SUBJECT: WR2 Wireless Rain Sensor Product Enhancements

Model	Product ID
WR2-RC	A553000
WR2-RFC	A553100
WR2-RFC-868	A553300
WR2-RC-AUNZ	A553400

IMPLEMENTATION DATE CODE: January 13, 2014

2. Wiring into irrigation controller sensor ports

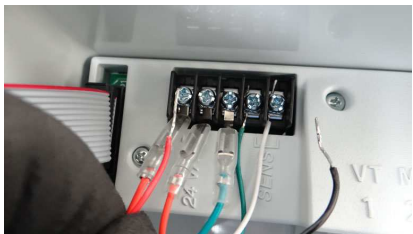
Connect green & white wires to "sensor" terminals

Connect red & black wires to "24VAC" terminals

3. Correct location of battery contact arm

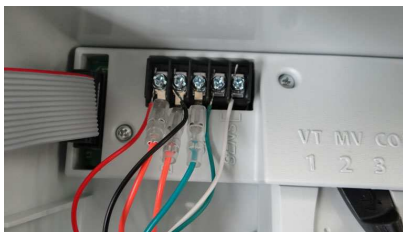
Incorrect location of battery contact arm

Contact should extend "well above" floor of battery cassette
